**ROSETREE COTTAGE,
HIGH STREET, NEWNHAM.**

PROPOSED FLOOR PLANS.

GROUND FLOOR PLAN

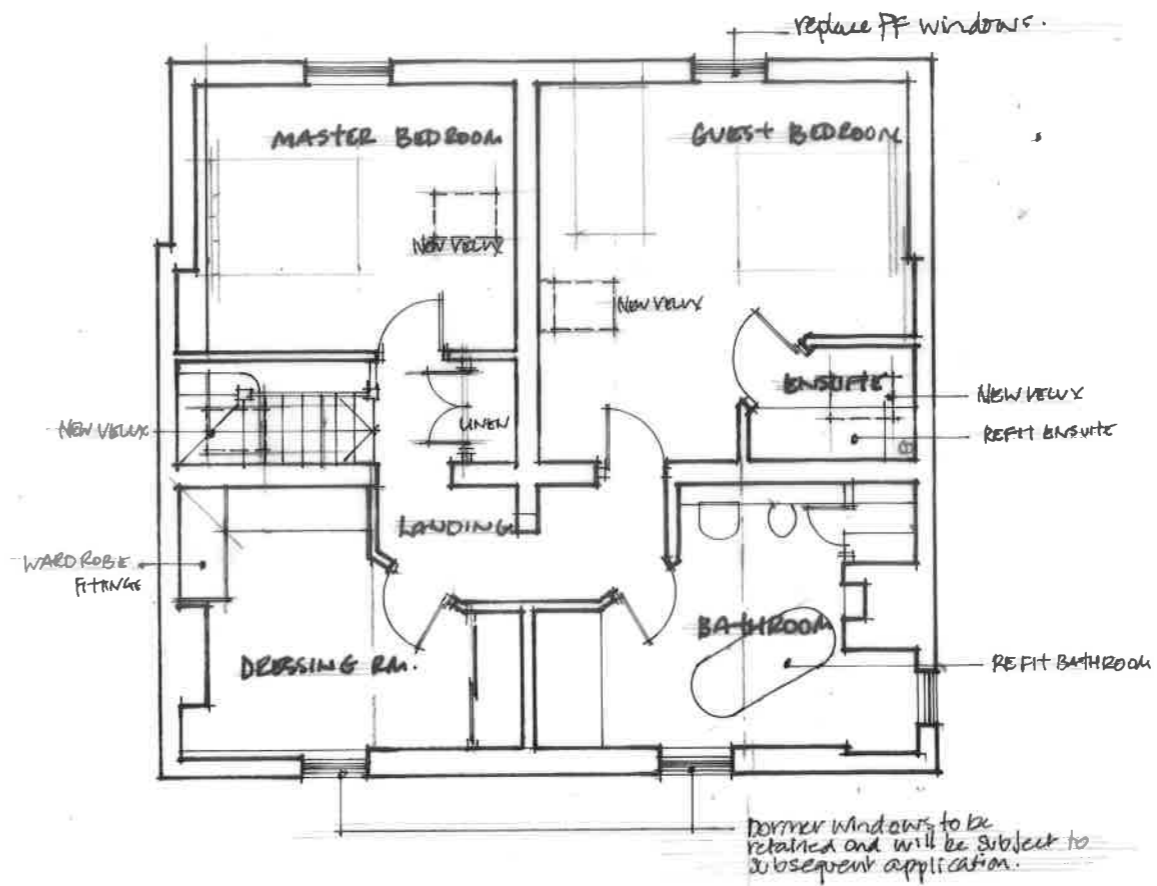
Replace GF windows

porch to stay as existing pending further application

Replacement porch not included in this application. porch to be subject of subsequent application

porch and dormer windows omitted from plan
